November 8, 2016

03800 Version 1

Warranty Extension: 2007–13 MDX and 2010–12 ZDX Rear Active Damper

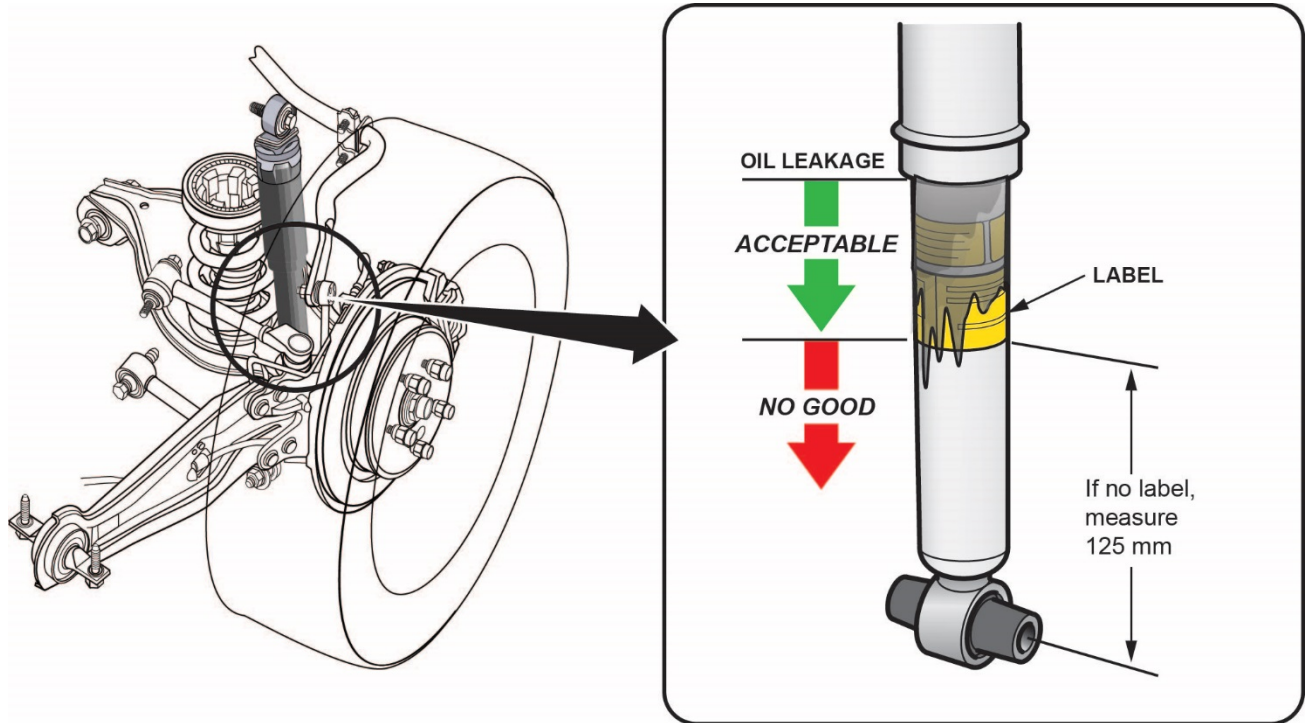
Place the vehicle on a flat surface or raise it on a lift, then inspect the rear dampers for leakage by checking if the oil stains extend below the bottom of the damper label.

NOTE: If the label is damaged or missing, measure a line that is 125 mm above the center of the lower mounting bolt eye. This would be the location of the bottom of the label.

- **If the oil stains extend below the bottom of the damper label**, go to REPAIR PROCEDURE.
- **If the oil stains do not extend below the bottom of the damper label**, this warranty extension does not apply. Continue with normal troubleshooting.
